RE: Stormwater Analysis – 51 S. Main Apartments
51 South Main Street, Waterbury, Vermont

51 S. Main St. – DRB comment response

Original DRB comment list.

PROPOSED SITE PLAN

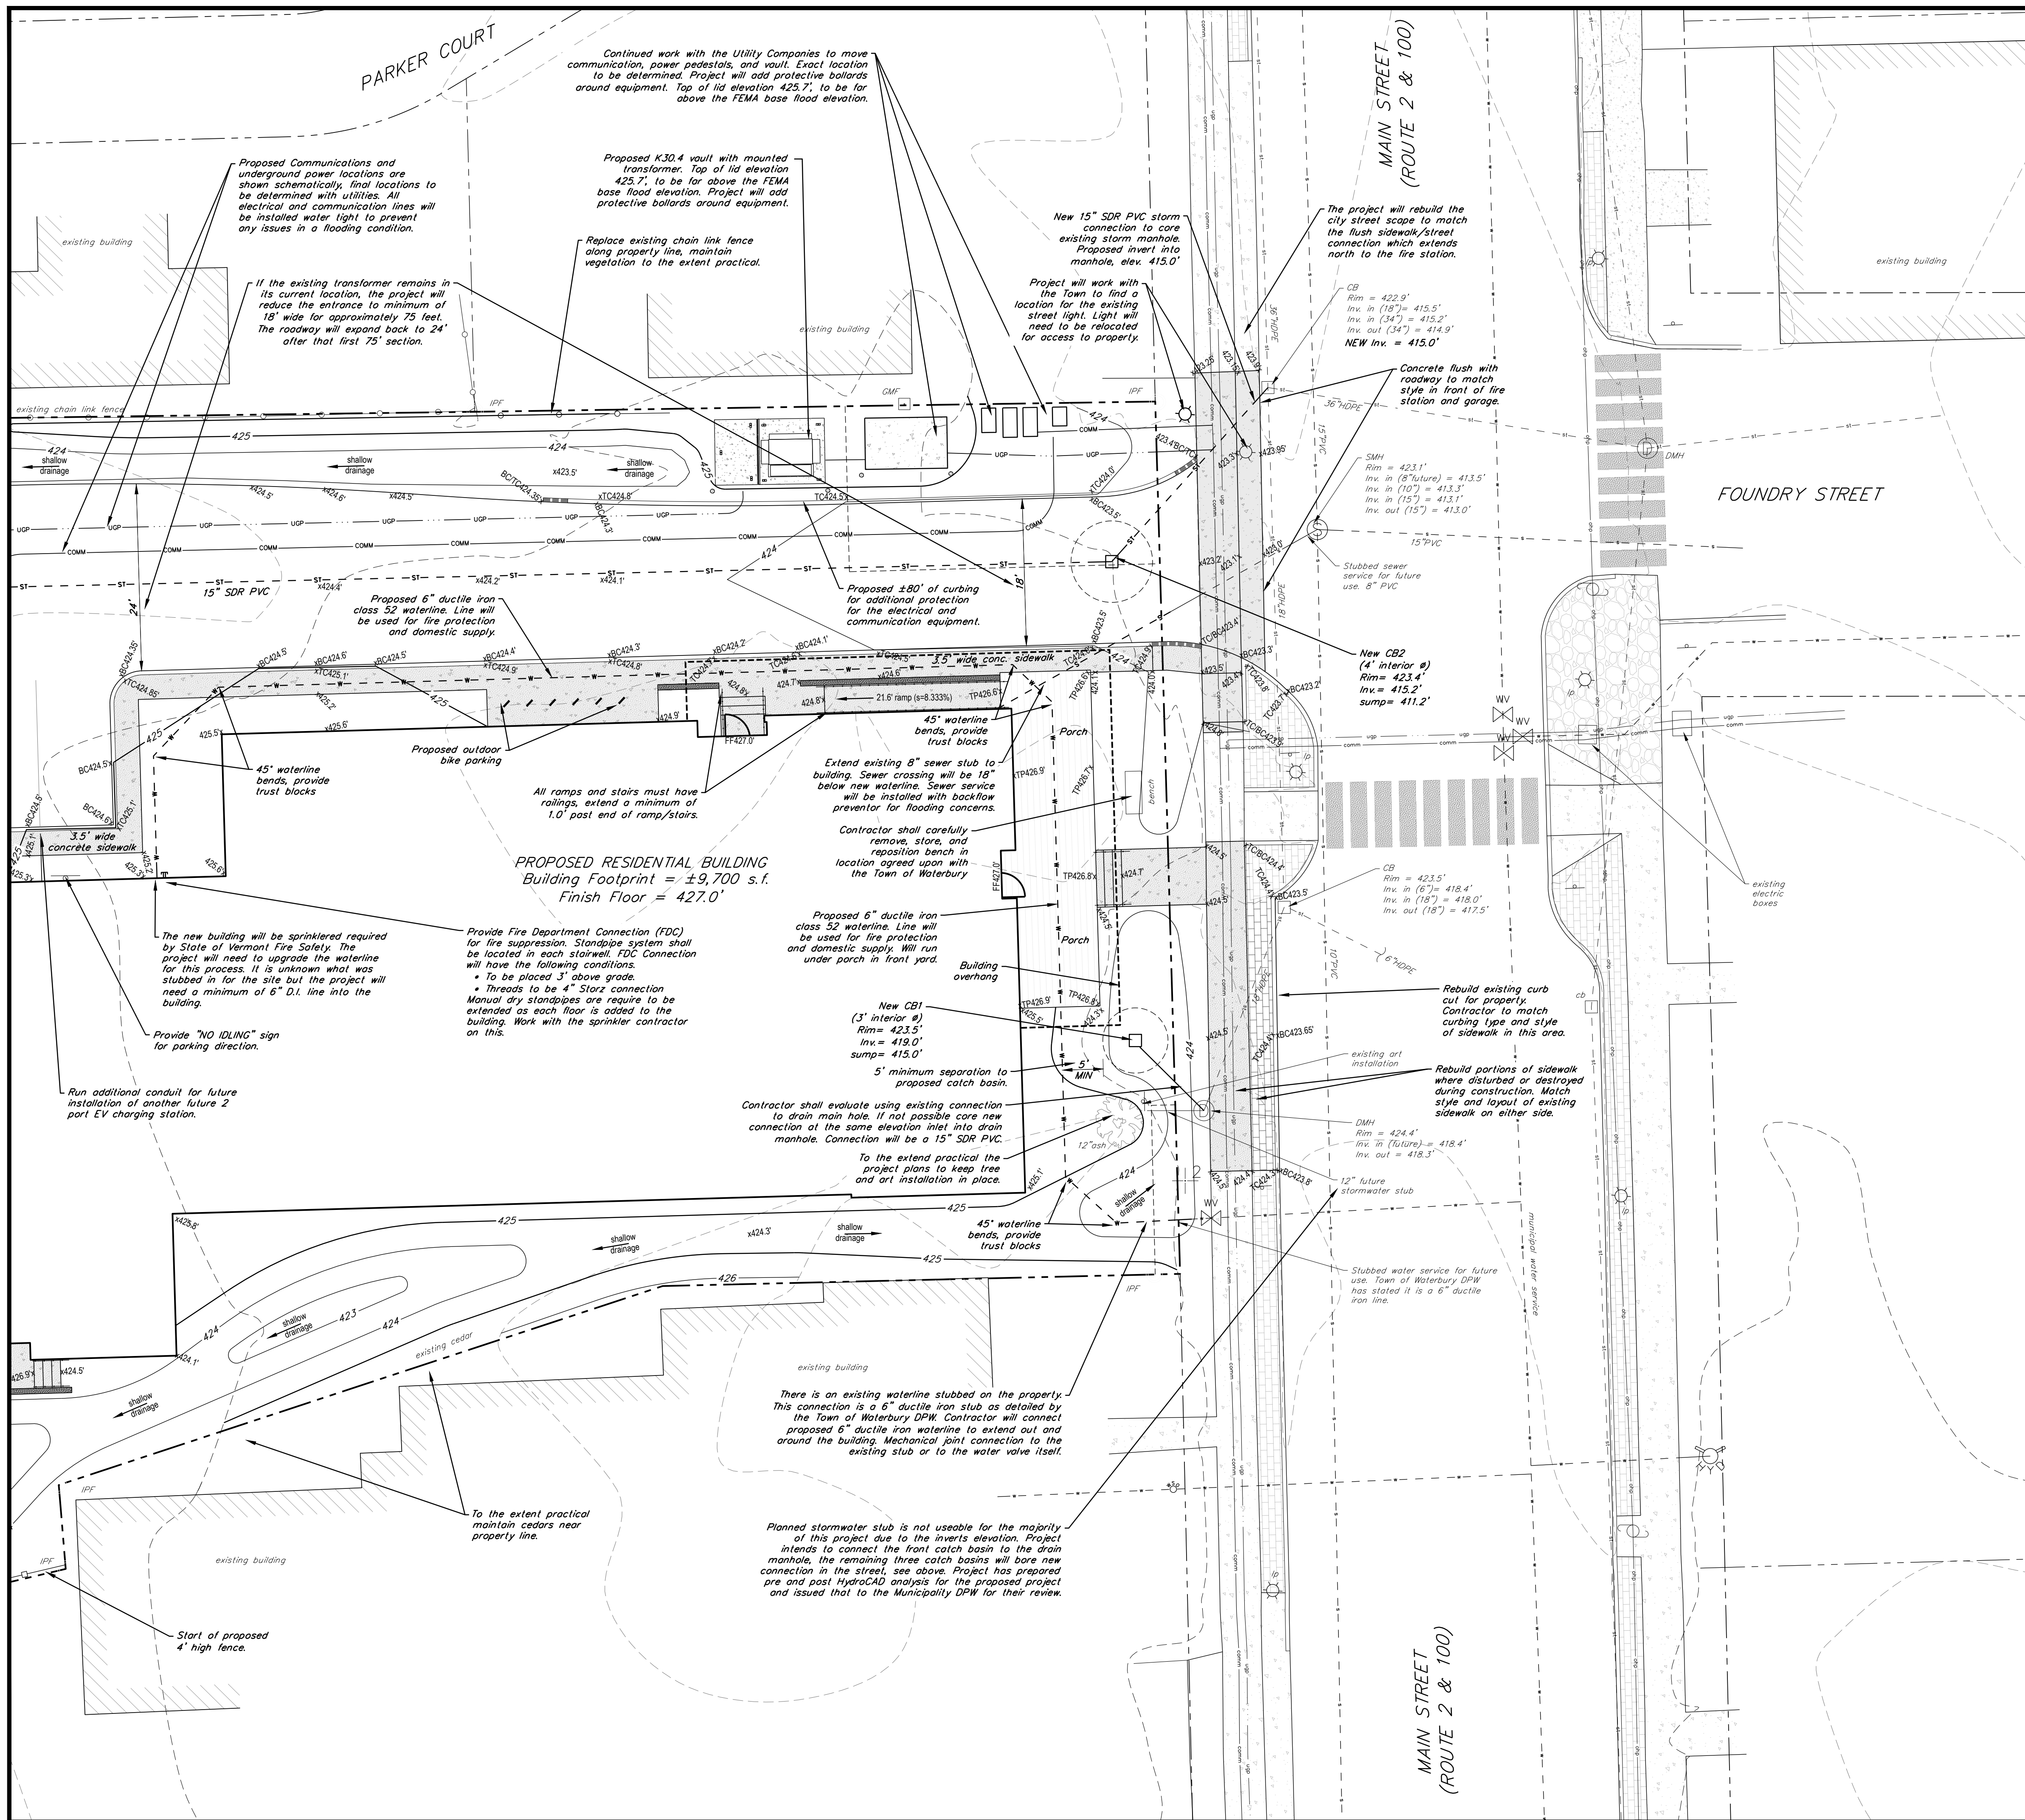
- **Provide compensatory storage calculations.**
Compensatory removal calculations were shown on the plans originally submitted to the Town for the last meeting, they were shown on C-1.00 of the Civil Engineering Plan Set. Krebs and Lansing added more detail to that calculation to provide the Town and Board with further values for their review. These values and plans have also been supplied to Ned Swanberg, CFM Vermont Flood Hazard Mapping Coordinator Regional Floodplain Manager. Neal Leitner, Town of Waterbury, was included on those correspondence.
See Civil Site Plan C-1.00

EXISTING CONDITIONS PLAN

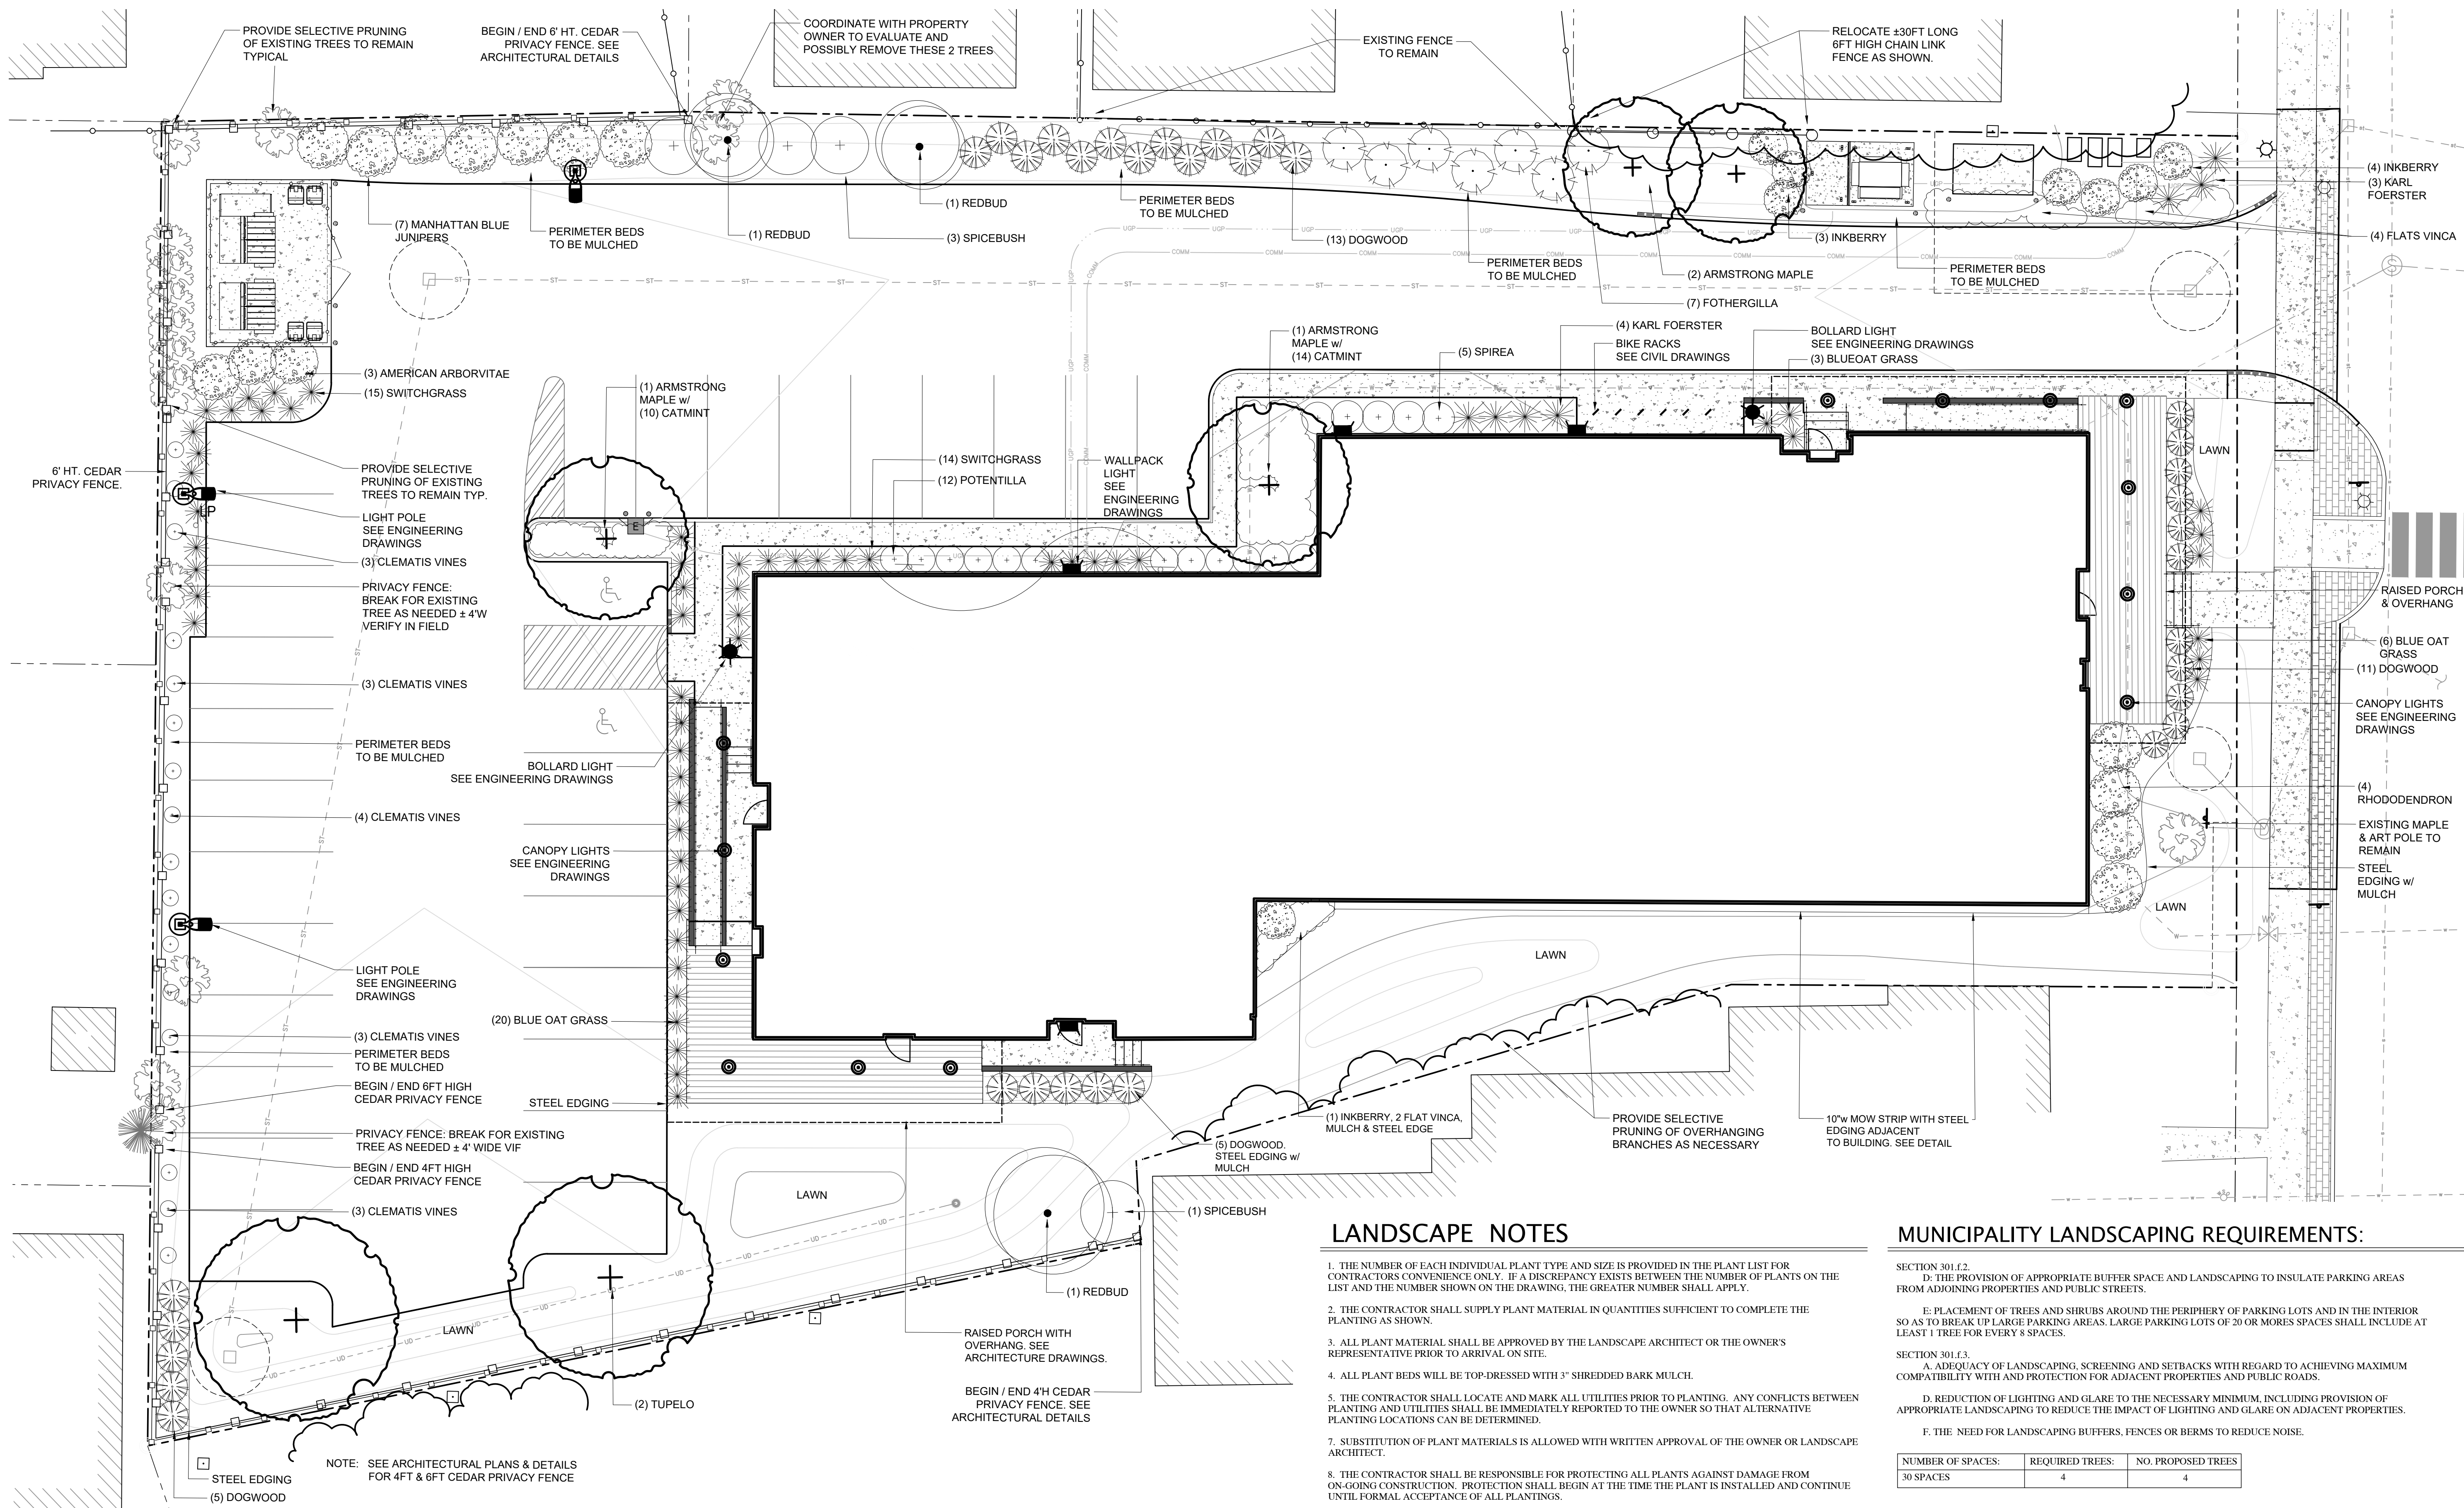
A note has been added to the drawings to return the crabapple trees to the town. They are beautiful trees, but at this time, Downstreet does not use fruit bearing trees in their buildings due to maintenance concerns.
Note added to L1.0
- **Place lights on a dimmer after 10pm**
